Duquesne Light

SUBJECT: Beaver Valley Power Station - Unit No. 2
Docket No 50-412
Fire Protection - Draft Safety Evaluation Report

Status of Fire Protection
Draft SER Open Items

RESPONSES TO DRAFT
SAFETY EVALUATION REPORT
FIRE PROTECTION OPEN ITEMS

TITLE		FIGURE FP-2a PLANT ARRANGEMENT		 Duquesne Light Company	
FOR		SCALE	DRAWING NO.	SHEET	REV.
BEAVER VALLEY POWER STA		—		1 OF 4	0

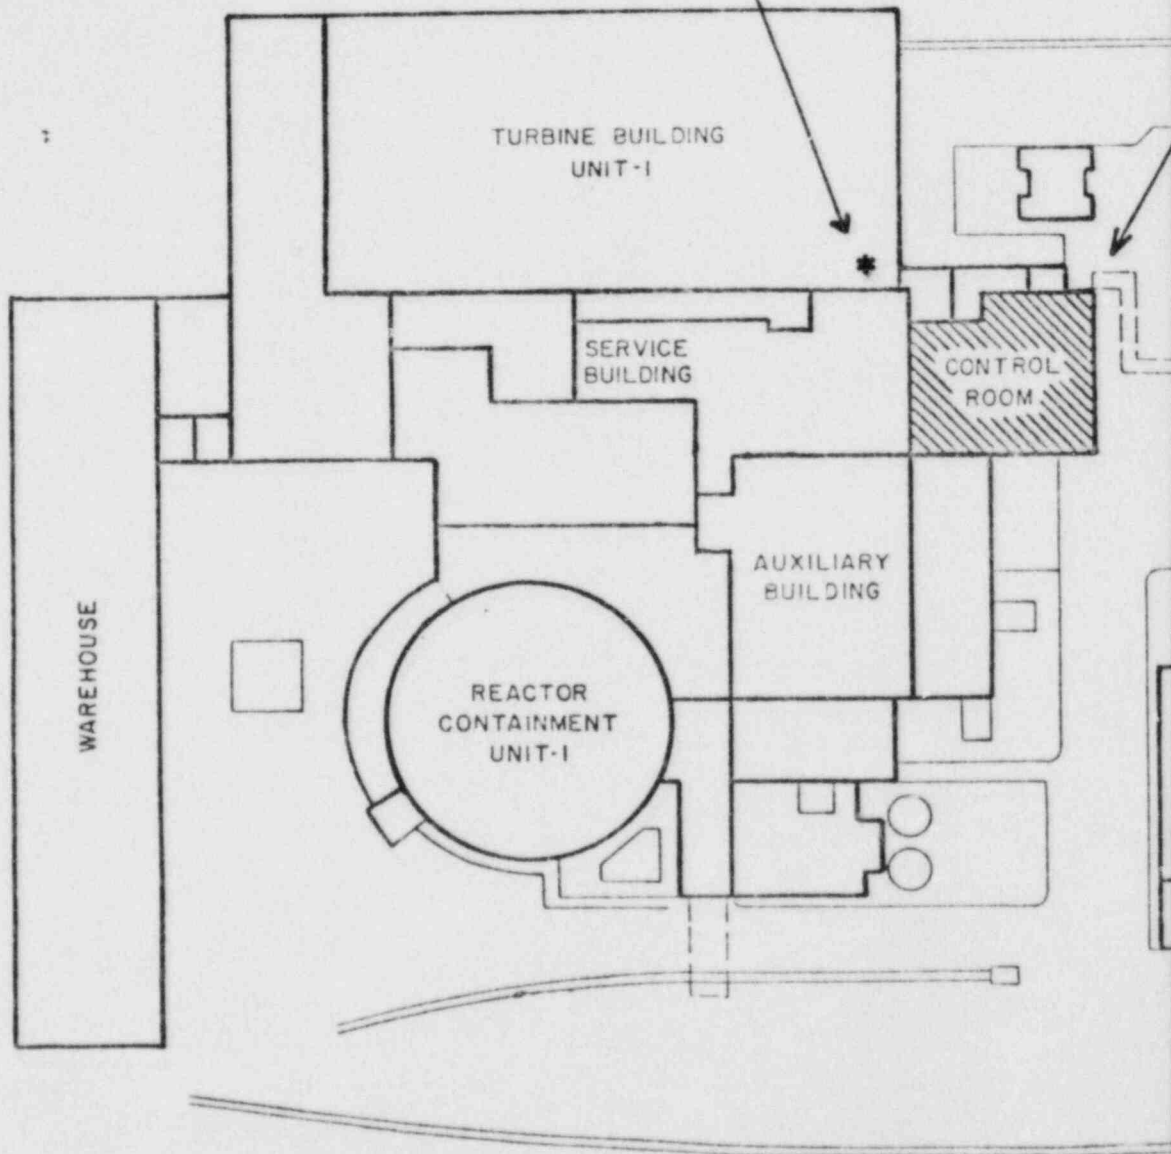
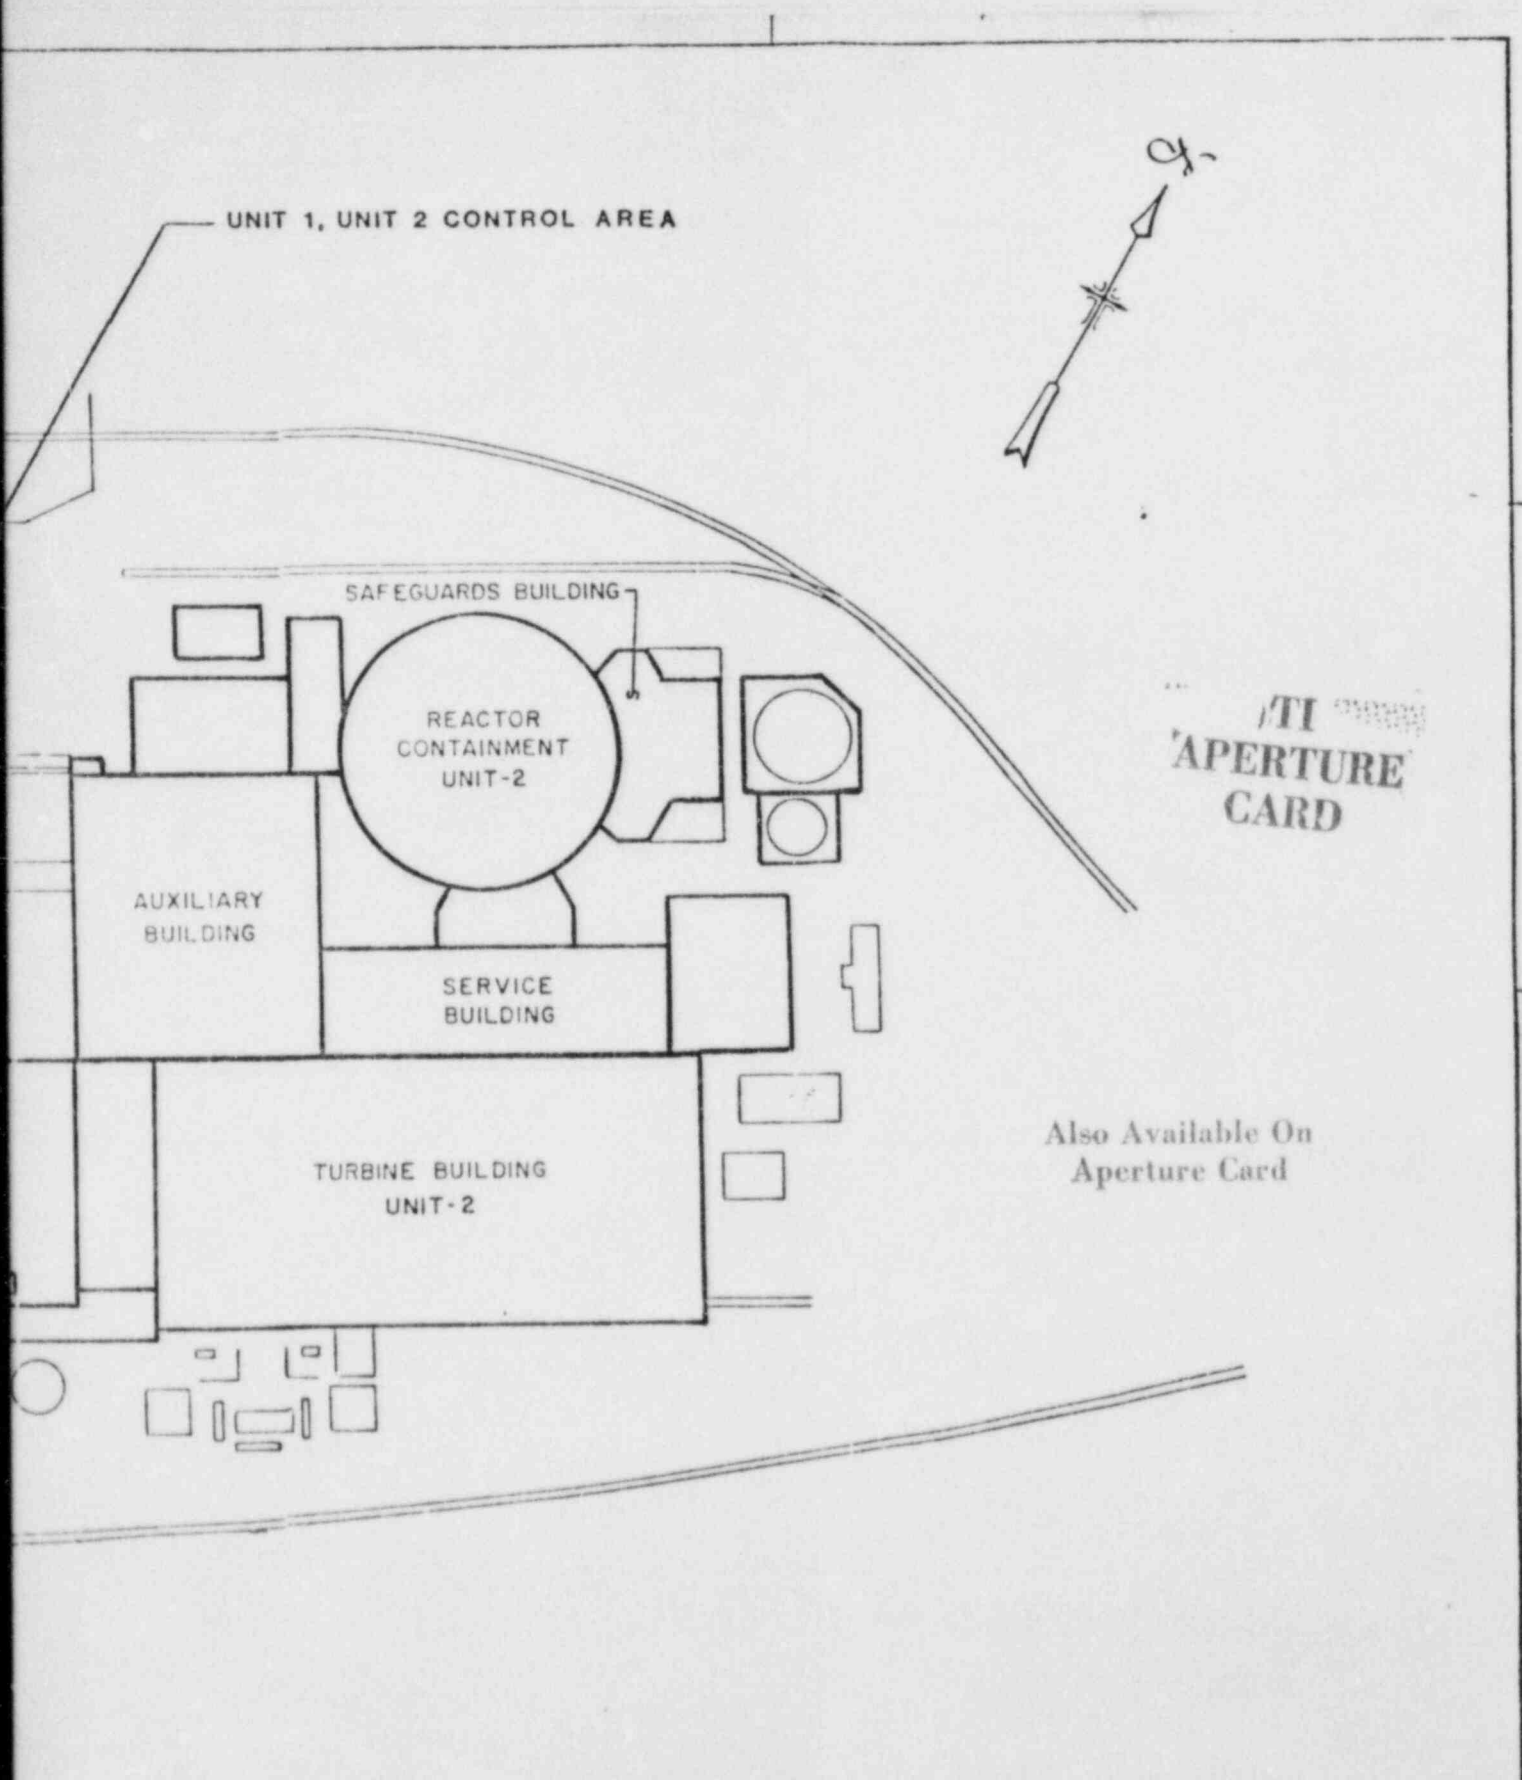
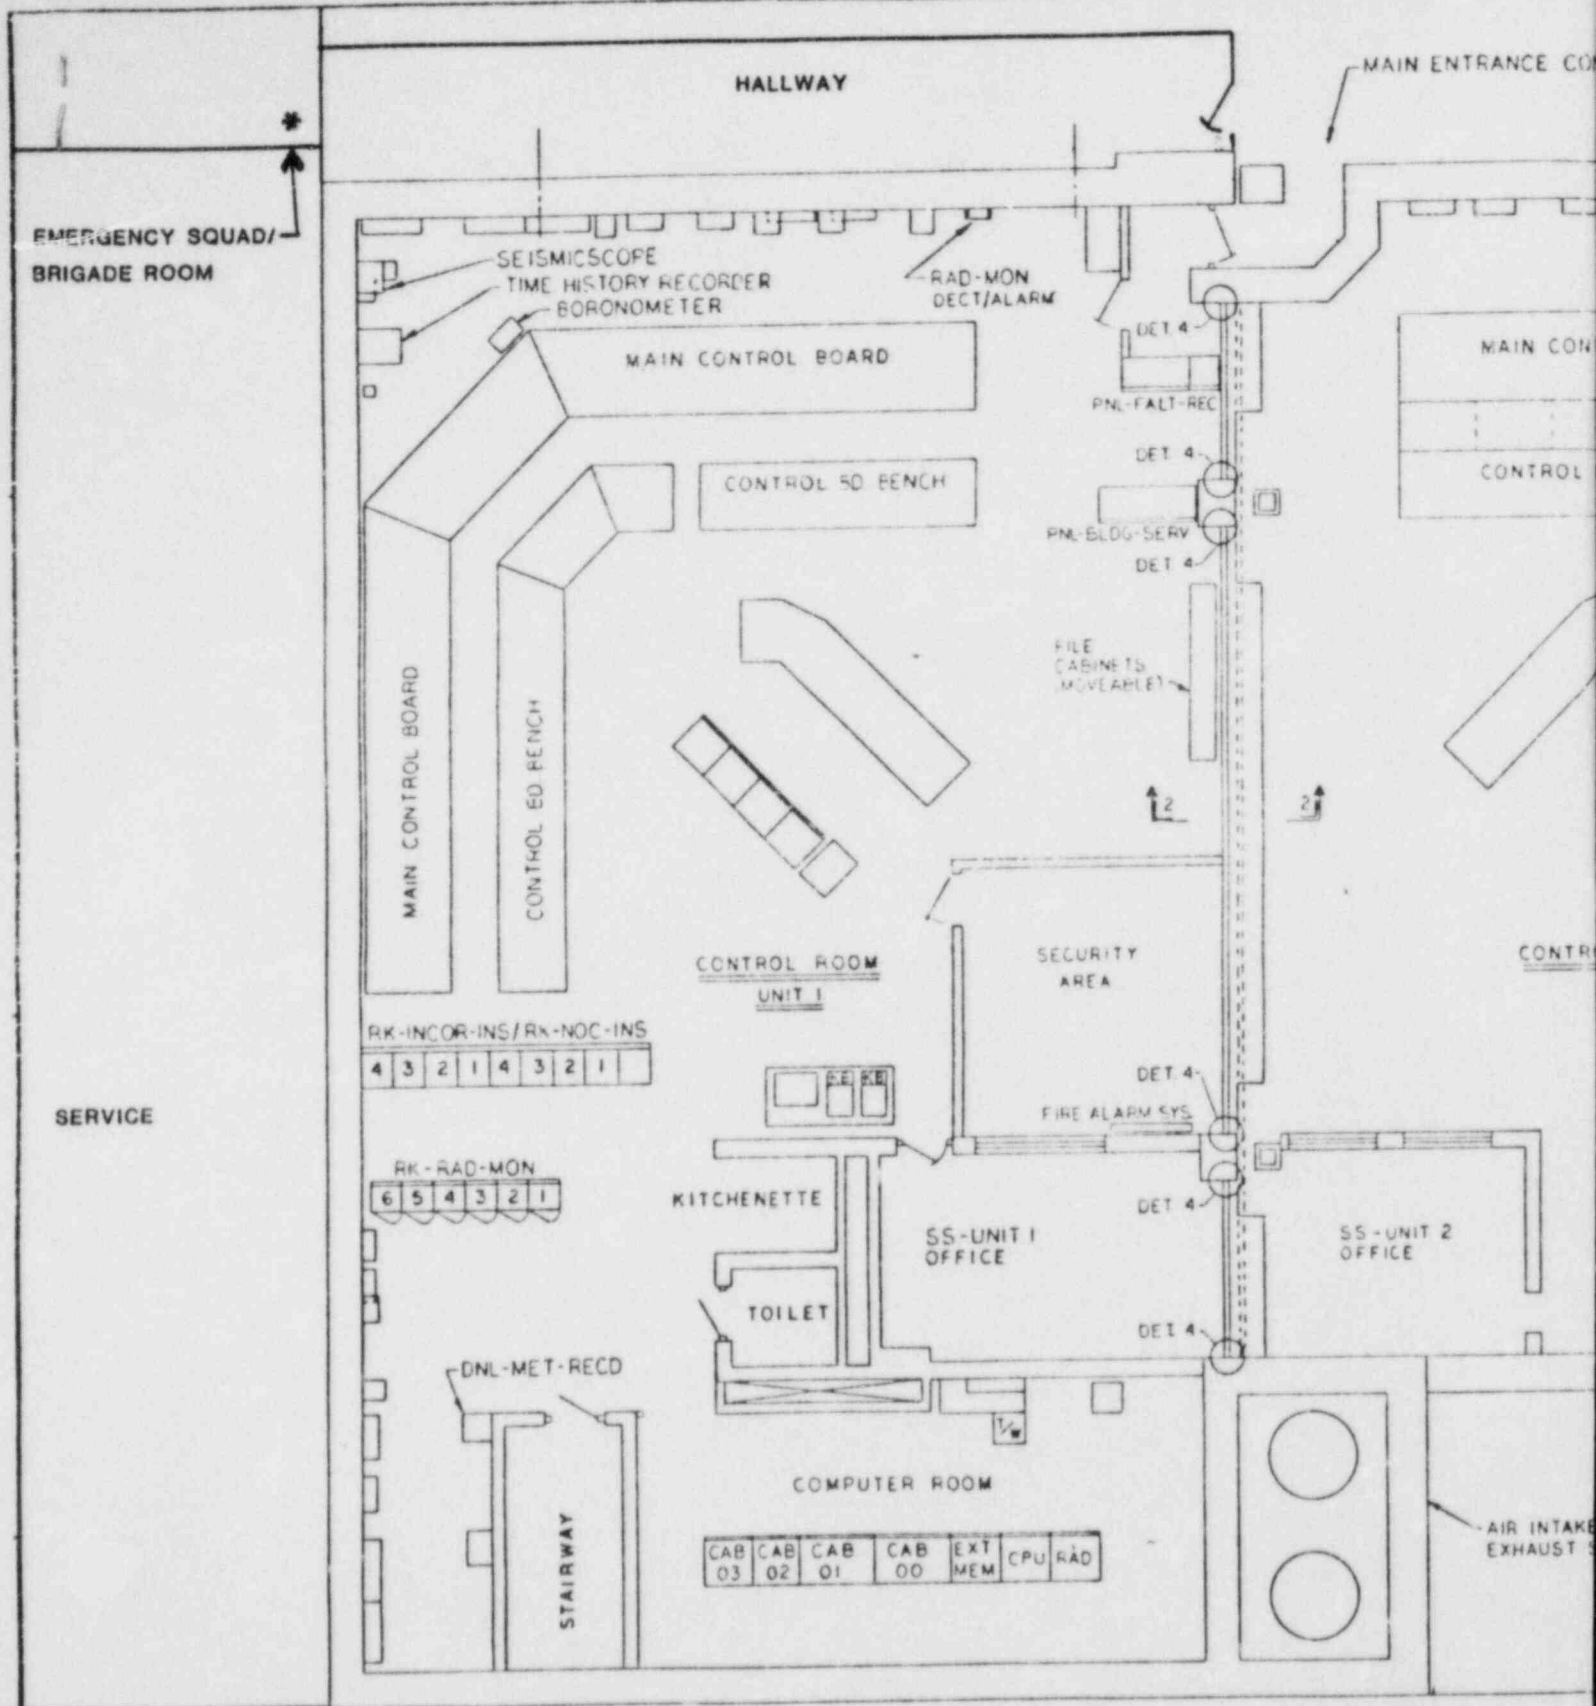
The applicant has not specified the quantity of self-contained breathing apparatus nor the quantity of extra air cylinders maintained on site. The applicant proposes to give physical examinations to the fire brigade members every 3 years instead of annually as specified in our guidelines. We will require that the applicant provide details showing compliance with the guidelines in BTP CMEB 9.5-1, Item C.3, concerning the quantity of self-contained breathing apparatus, spare cylinders, and physical examination frequency.

The Emergency Squad/Brigade Room, which contains the fire protection equipment for the fire brigade, is shared by Units 1 and 2. This fire staging area is located directly outside the control room on elevation 735.5 ft in the BVPS-1 turbine building as shown on Figures FP-2A and -2B. This staging area and the equipment will be shared by both Units 1 and 2 fire brigades.

BVPS-2 complies with BTP CMEB 9.5-1, Item C.3, concerning the quantity of self-contained breathing apparatus and spare cylinders. At least ten self-contained breathing apparatus are available for fire brigade personnel on BVPS-2, with at least two extra air bottles for each self-contained breathing unit. At least five of these breathing apparatuses are located in the brigade room with five additional units at a strategic location within the plant. An air compressor dedicated to supplying breathable air for replenishing exhausted air bottles is located in the BVPS-1 turbine building. The air compressor satisfies the requirement for an onsite 6-hour supply of reserve air.

DATE	5-8-84							TITLE: FIRE PROTECTION DETECTION AND SUPPRESSION POWER SUPPLY	REF:
PREP.	DH								
CHECK	5	4	3	2	1				SKETCH FP-9
APPR.

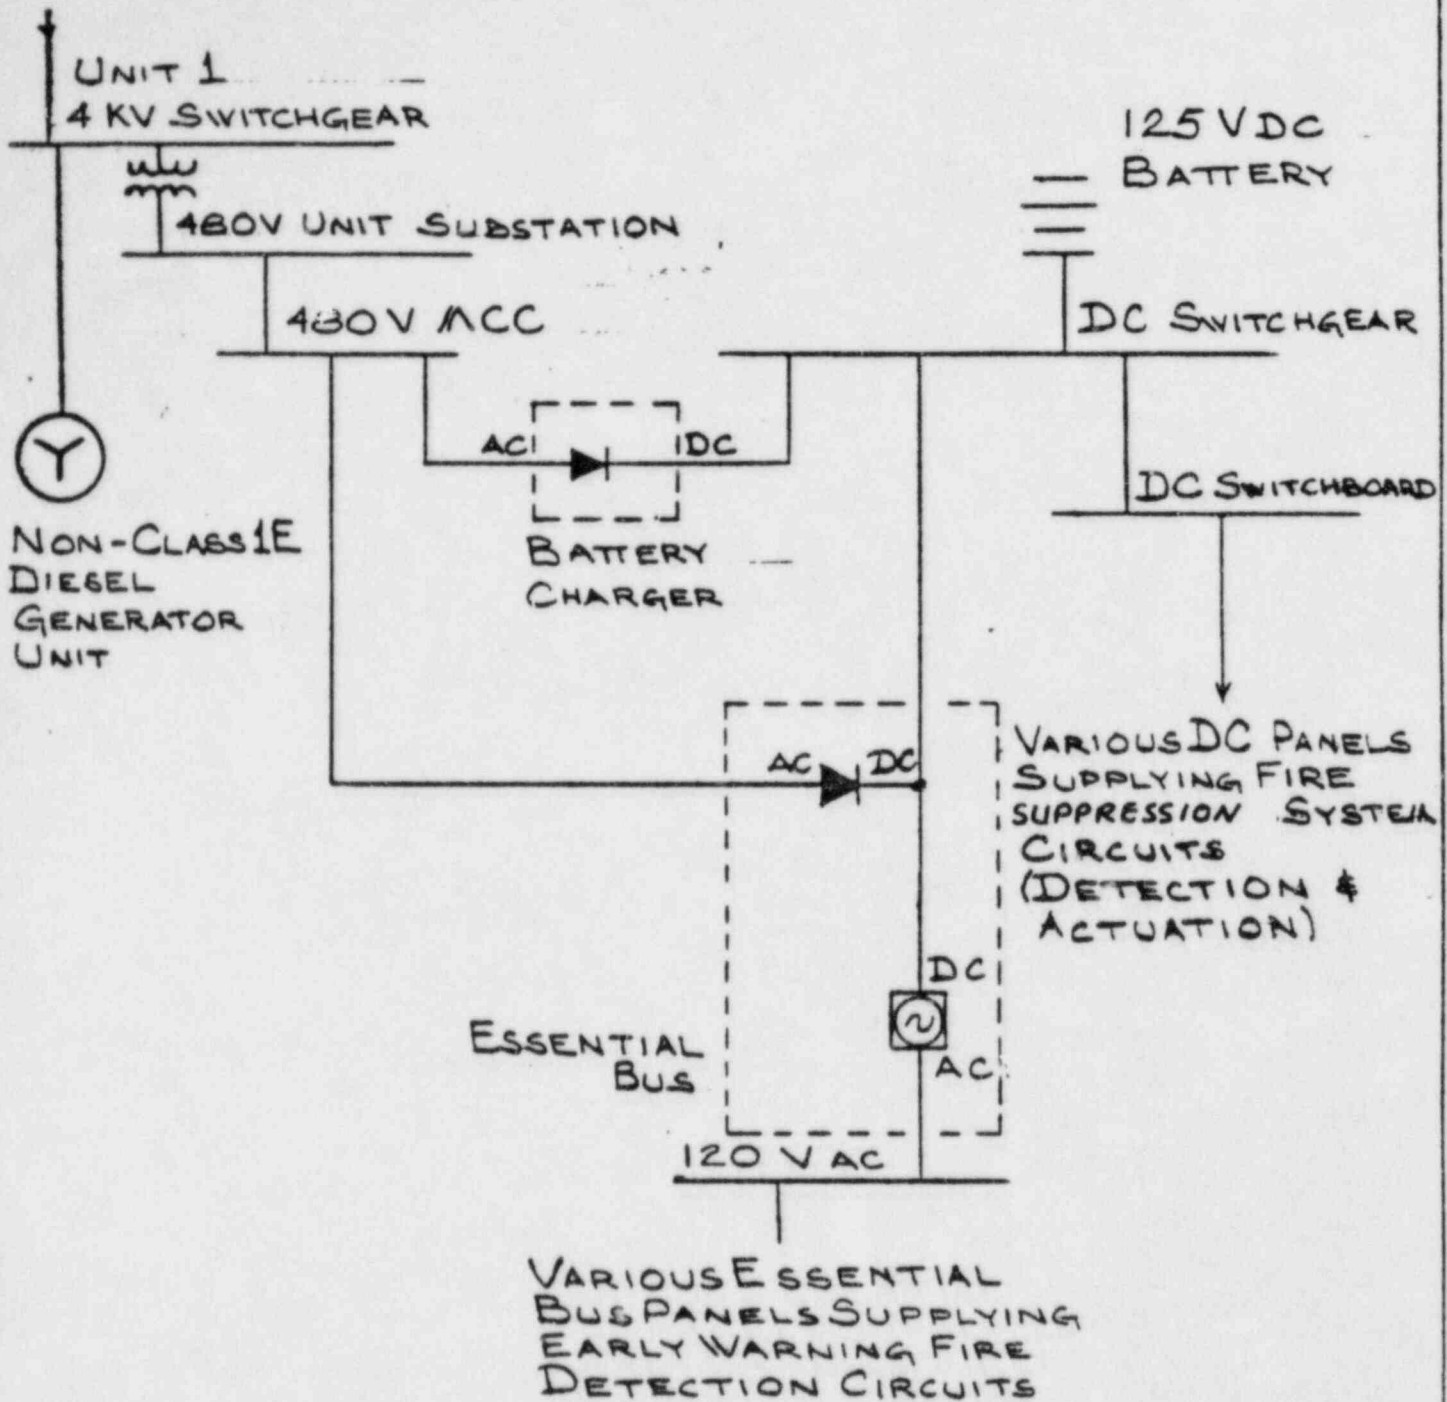
The licensee has not provided information on whether they meet Section 2220 of NFPA Std. 72D. We will require the applicant to verify that reliable power supplies, as recommended by Section C.6.b of BTP CMEB 9.5-1, will be provided. This can be accomplished by using normal offsite power as the primary supply with a 4-hour battery supply as secondary supply, and by providing capability for manual connection to the Class 1E emergency power bus within 4 hours of loss of offsite power. Such connection should follow the applicable guidelines in Regulatory Guides 1.6, 1.32, and 1.75.

The primary supply for the early warning fire detection system and the independent fire detection and suppression systems is the normal offsite power supply system.

The secondary supply for the fire detection systems is the ERF nonsafety diesel generator. The switchover capability is an automatic function. The ERF diesel generator supplies the 120-V ac uninterruptible power supply system required for the early warning detection system and the 125-V dc panels for the fire detection and suppression systems.

A battery backup system with a 2-hour rated capability is provided as a backup to the 125-V dc systems.

A battery backup system with a 30-minute capability is provided as a backup to the 120-V ac systems. This is to provide electrical power continuity for the 10 seconds required to start the ERF diesel and achieve rated voltage and frequency. See attached Figure FP-9.
